Access Compliance Report

Public Rights-of-Way

(Pedestrian Signals)

Intersection ID: N/A	Main Street:	Cross Street: N/A	Location: N/A
ADA ID: EE05BFD86E16	Signal Type: One Push Button-APS	Overall Compliance: No	Severity Score: BTN 1: N/A BTN 2: N/A No BTN: N/A
Codes/Mitigation Info/Possible Solution		Field Measurements/Component Compliance

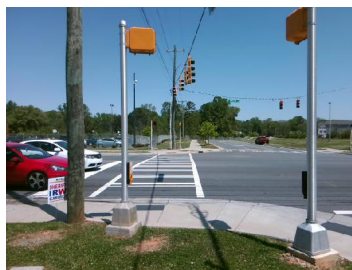
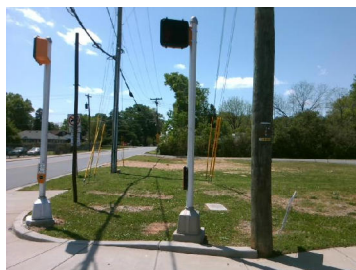
Possible Solutions: Replace Signal Push Button With APS Button on New Post. Remove & Relocate Sign.

PROW/ADA: , TMUTCD 4e.08, R404.7.3

Yes B 1 Clear Xing Direction?	ClearlyMarked	N/A B 2 Clear Xing Direction?	N/A
B 1 Crossing Direction	To NE	B 2 Crossing Direction	N/A
Yes B 1 DistanceTo XWalk (in)	0.0	N/A B 2 DistanceTo XWalk (in)	N/A
No B 1 DistanceTo Curb (in)	89.0	N/A B 2 DistanceTo Curb (in)	N/A
Yes B 1 Diameter (in)	2.0	N/A B 2 Diameter (in)	N/A
